A Textron Company

412-19-243

MODEL AFFECTED: 412

SUBJECT: MAIN DRIVESHAFT RETAINER P/N 205-040-175-001, MODIFICATION OF

Figure 1 – Grease Retainer

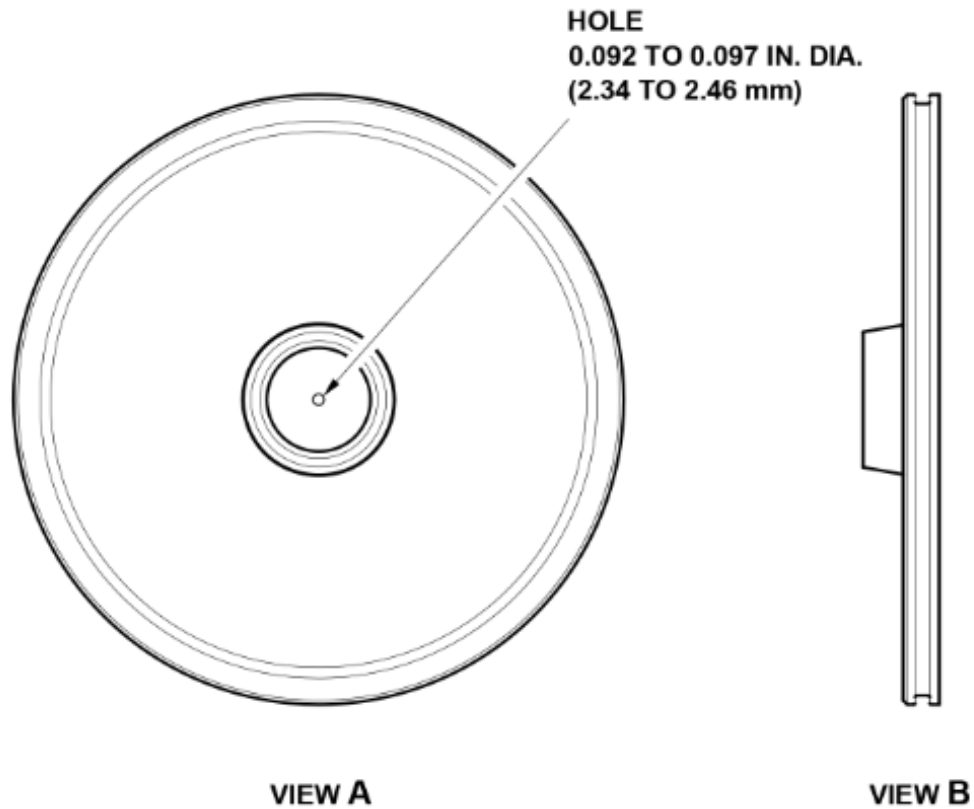
This Bulletin introduces a product modification to the 205-040-175-001 retainers of the 212-040-005-103 driveshaft assemblies to improve grease retention. The modification consists of drilling a vent hole in the center of the Retainer P/N 205-040-175-001.

The new spares retainer configuration, 205-040-175-115, will have a vent hole drilled in the center. Once this technical bulletin is accomplished, the 205-040-175-001 retainer will be equivalent to the 205-040-175-115.

1. Prepare the helicopter for maintenance.
2. Remove the main driveshaft assembly from the helicopter (BHT-412-MM, Chapter 63).
3. Remove the grease retainers P/N 205-040-175-001 from each end of the main driveshaft assembly P/N 212-040-005-103 (BHT-412-CR&O, Chapter 63).
4. Thoroughly clean the retainers using dry cleaning solvent (C-304) and dry the parts using dry filtered compressed air.
5. Secure the retainers flat and drill a 0.092 – 0.097-inch diameter hole directly in the center of each retainer as shown in Figure 1.
6. Deburr the holes to remove sharp edges.
7. Carry out chemical film treatment (alodine) (C-100) on the repaired areas (BHT-ALL-SPM, Chapter 3).

Figure 2 – Main Driveshaft Coupling Assembly

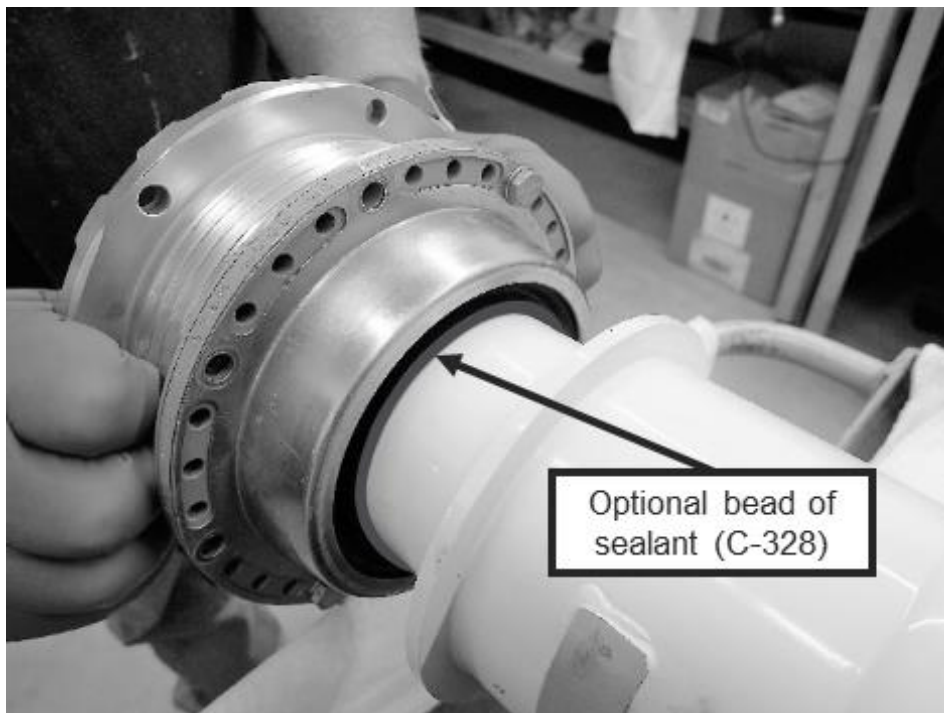
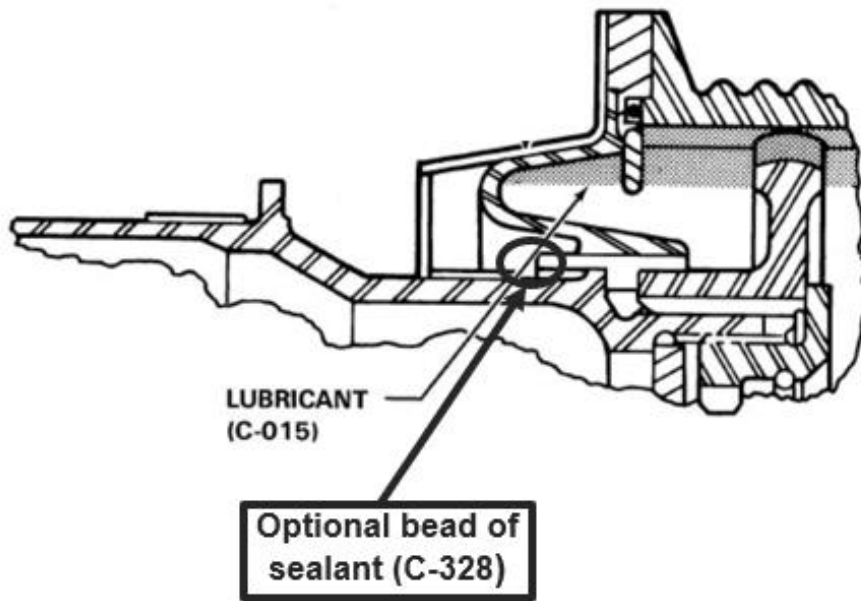
8. Re-install the retainers on the main driveshaft. (BHT-412-CR&O, Chapter 63).
9. Application of a small bead of low adhesion sealant (C-328) between the mating surfaces as shown in Figure 2 is optional.
10. Make an entry on the helicopter logbook and historical service records indicating compliance with this Technical Bulletin.
